MAJOR PROJECT APPLICATION MP10_0068

**PREFERRED PROJECT REPORT AND RESPONSE TO SUBMISSIONS
UNDER PART 3A OF THE EPA ACT 1979**

WESTFIELD PARRAMATTA DEVELOPMENT

**June 2013
Job No. 09150**

Figure 1 – new streetfront tenancy

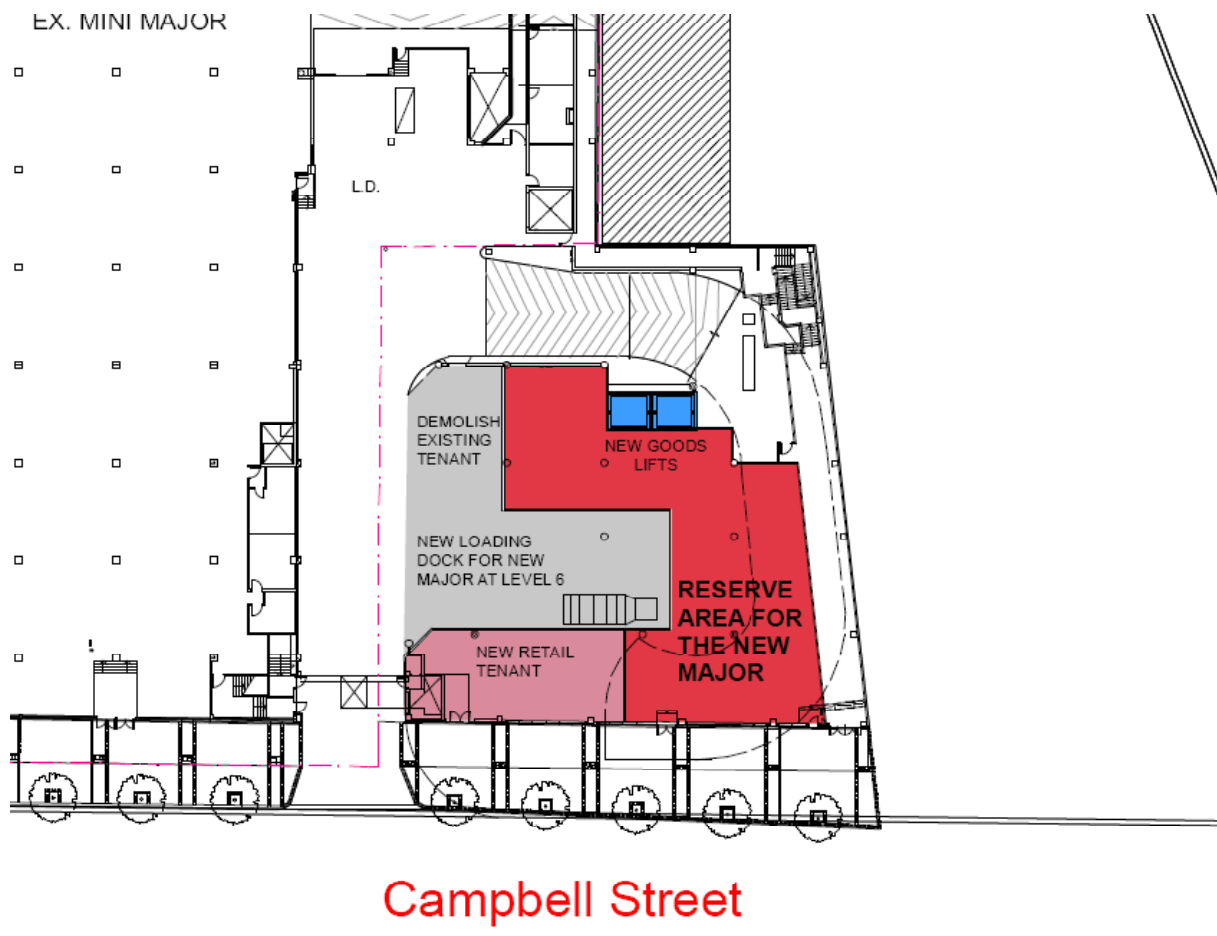
The DP&I requests that consideration be given to addressing the impact of inactive facades at ground floor level and alternative treatments to activate these facades, including insertion of shopfronts, access points etc.

As noted above there are minimal changes proposed at ground level of the existing development in both Stages 1 and 2. The only location with any real relationship with the streetfront is at Level 3 near the corner of Church and Campbell Streets (see **Figure 1**). Here a retail tenancy is provided at the streetfront.

Stage 2 is a new office tower that sits above the podium and will utilise the entry off Church Street for the existing commercial building. Therefore again there is nothing in this proposal that prompts the need to require streetfront activation.
